Economic Commission for Europe**Inland Transport Committee****World Forum for Harmonization of Vehicle Regulations****Working Party on General Safety Provisions****Ninety-eighth session**

Regulation No. 43 (Safety glazing)**Proposal for amendments to Regulation No. 43****Submitted by the expert from the European Association of Automobile Suppliers***

The text reproduced below was prepared by the experts from the European Association of Automobile Suppliers (CLEPA) to transpose the requirements of global technical regulation No. 6 in Regulation No. 43. It is based on informal document GRSG-97-02-Rev.1. It takes into account informal document GRSG-97-15 as well as the comments received from GRSG participants. The modifications to the current text of the Regulation are marked in bold or strikethrough characters.

“Glass-plastic panes other than windscreens

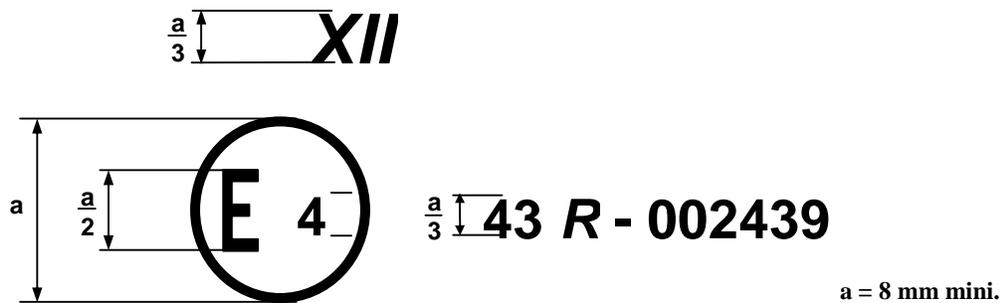
Annex 2, add the following approval mark example, to read:

The above approval mark affixed to glass-plastic pane other than a windscreen, shows that the component concerned has been approved in the Netherlands (E 4) pursuant to Regulation No. 43 under approval No. 002439. The approval number indicates that the approval was granted in accordance with the requirements of Regulation No. 43.”

Figure 1: Support for ball tests”

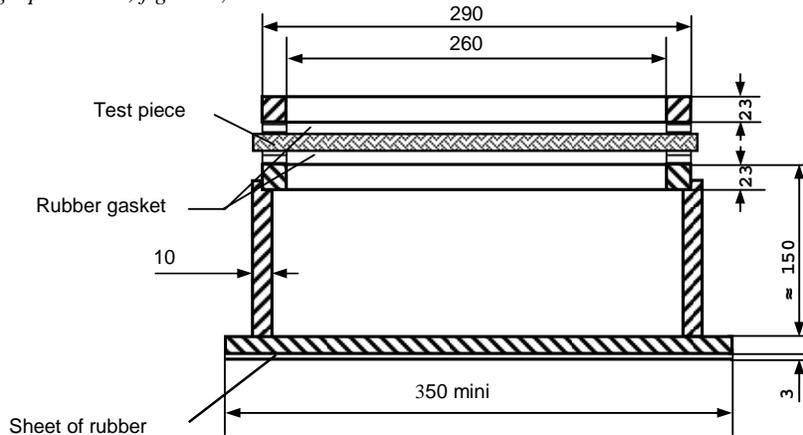
Paragraph 2.1.1.3, figure 1, amend to read:

Figure 3: Prescribed points of impact for uniformly toughened glass panes”

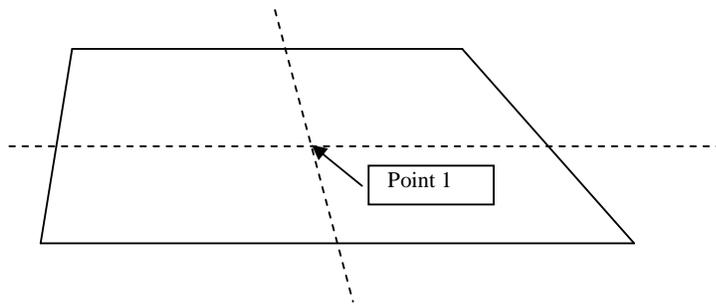
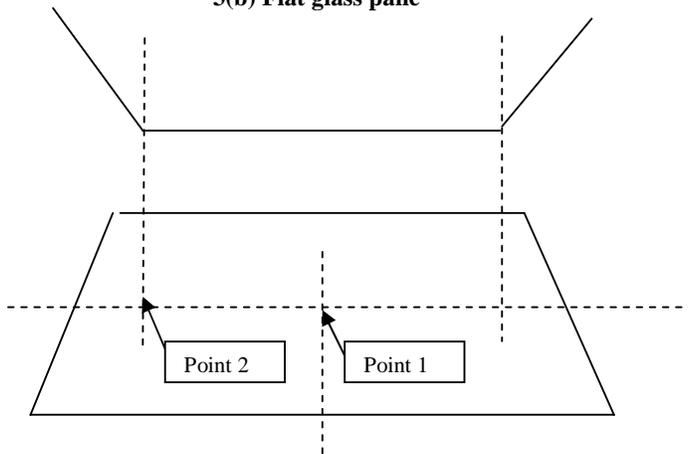
Annex 17, figure 3, amend to read:
